## UDRP Comments 2019 January 23 (including applicant response)

Re: SOUTH MACLEOD CENTRE CALGARY  
OUR PROJECT #216065 – 6.1  
RESPONSE TO URBAN DESIGN REVIEW PANEL AND DETAILED TEAM  
REVIEW 2 COMMENTS  
DEVELOPMENT PERMIT NUMBER: DP2018-2164 (LOT 7)

Figure 1 – South Macleod Centre Area Structure Plan with DP overlay

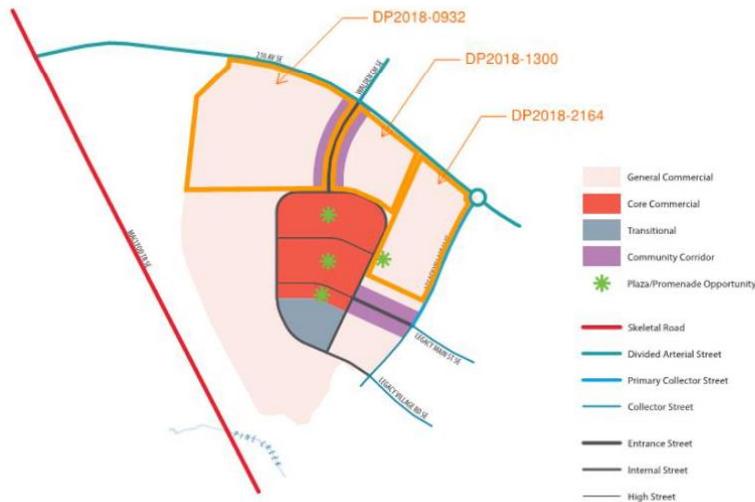
2. That said, the masterplan was not provided to the Panel, although it was briefly referred to and presented as a single slide in a presentation. It would be typical that the Panel would have access to the Masterplan to be able to review the applications for compliance. The Masterplan would set in place the long term vision for pedestrian movement, public space, green space, overall massing, form and density and would give the reviewers the ability to understand how each subsequent development would anticipate and set in place a framework for success for the next. Some general principals were discussed but not at the level of detail expected in an application of this size.

- Of particular note were comments by the applicant that they do not anticipate building to the level of density allowed for by zoning. This is an important consideration, as the full FAR determines the extent of roadwork infrastructure required. Plans indicate a six lane roadway entering the site and four lane roadways for the most part elsewhere. The Panel is concerned that the road network is sized for a full build out that will never be realized, and, is far larger than would be desirable for a walkable, self sustaining community which the applicant states is the intent. The applications provide no explanatory diagrams to illustrate the guiding urban design concepts, massing distribution, gateway or other feature massing elements, viewlines, greenspace concepts or dedicated routes for bicycle or pedestrian movement. These are elements that should be described and presented as a whole before approvals are provided for individual developments.

Figure 1 below illustrates the ASP Concept Plan with the locations of the three current applications overlaid on the Masterplan.
